Planning and Zoning Commission

Primrose School - Signs 22-181MSP

Proposal Request for a Master Sign Plan to permit two wall signs for an existing daycare.

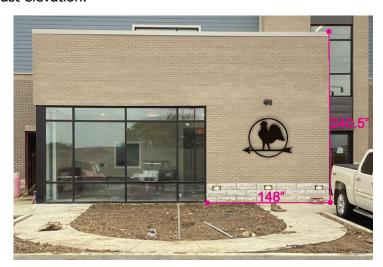
The applicant is proposing a primary wall sign on the east elevation of the building, and a logo wall sign on the west elevation of

the building. The primary wall sign is located along Abbey Lane, the sole street frontage for the site. The sign is approximately 45 square feet in size and approximately 25 feet in height. The sign will be constructed of 0.5-inch non-illuminated dark bronze letters pin-mounted to the Aged Copper metal panel above the front entrance. The building was approved and built with three decorative lighting fixtures to provide down lighting for a future wall sign.

The proposed height of the sign exceeds the maximum height for wall signs in the district, which requires the approval of the MSP. The sign location is consistent with the location conceptually provided with the approved FDP. The applicant has worked with Staff to simplify the design of the wall sign to create a dimensional sign that meets the aesthetic and creative requirements of a MSP.
